REQUEST FOR INFORMATION **DATE:** May 16, 2016 **NO.:** RFI-087

Project Name: Webster University Interdisciplinary Science Building Project No.: 15051

Subject: Clinical service sink clearance at cadaver lab

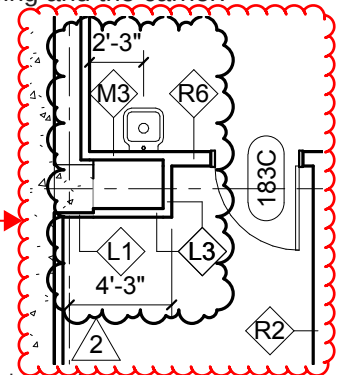
The clinical service sink called out on the South wall of the room requires a carrier, and needs a minimum of 12" of clear space inside the wall (including stud dimensions, excluding drywall) to contain the piping and the carrier.

Suggestion: Recommend creating a soffit/chase to increase the space for the piping.

Revise per attached sketch.
